# Access Compliance Report

## Public Rights-of-Way

### (Curb Ramps)

Intersection ID: 26209	Main Street: CARMEL_RD	Cross Street: JOHNSTON_RD	Location: NW
ADA ID: E95BE5B20B8E	Ramp Type: Perp	Initial Pass/Fail: Fail	Overall Compliance: No
Severity Score: 33.75			
Codes/Mitigation Info/Possible Solution		Field Measurements/Component Compliance

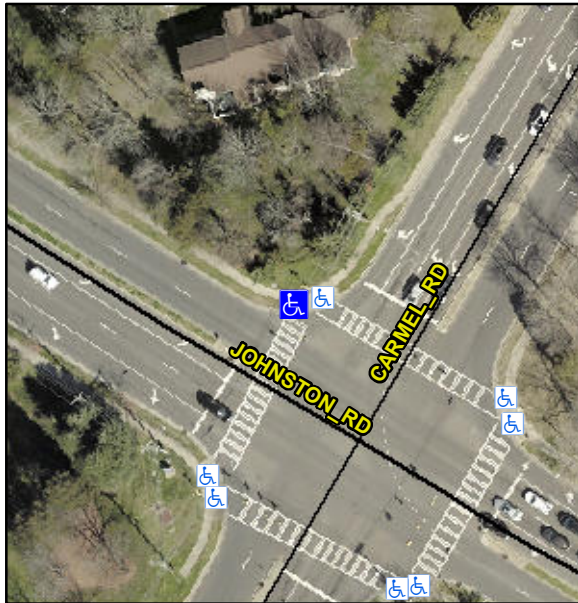
**Remove & Replace Entire Ramp.**

**R304.5.1, R304.2.2, R304.5.3**

Compliance	Description	Data	Compliance	Description	Data
N/A	Ramp Length (in)	60.0	No	Ramp Slope (%)	9.0
No	Ramp Width (in)	44.0	No	Ramp XSlope (%)	5.9
N/A	Flare Type LT	N/A	N/A	Flare Type RT	N/A
N/A	Flare Slope LT (%)	N/A	N/A	Flare Slope RT (%)	N/A
N/A	Flare Traversable LT?	N/A	N/A	Flare Traversable RT?	N/A
N/A	Landing Length (in)	N/A	N/A	DWS Provided?	N/A
N/A	Landing Width (in)	N/A	N/A	DWS Contrast?	N/A
N/A	Landing Slope (%)	N/A	N/A	DWS Length (in)	N/A
N/A	Landing X Slope (%)	N/A	N/A	DWS Full Width?	N/A
N/A	Landing Curb? (Y/N)	N/A	N/A	DWS Offset (in)	N/A
N/A	Shared Landing?	N/A			
N/A	Gutter Ponding?	N/A	N/A	Gutter Slope (%)	N/A
N/A	Gutter Lip Ht (in)	N/A	N/A	Gutter X Slope (%)	N/A
N/A	Painted X Walk1?	Yes	N/A	Painted X Walk2?	N/A
	X Walk 1 Direction	To SW		X Walk 2 Direction	N/A
N/A	X Walk 1 Width (in)	132.0	N/A	X Walk 2 Width (in)	N/A
	X Walk 1 Slope (%)	4.3		X Walk 2 Slope (%)	N/A
	X Walk 1 X Slope (%)	2.5		X Walk 2 X Slope (%)	N/A
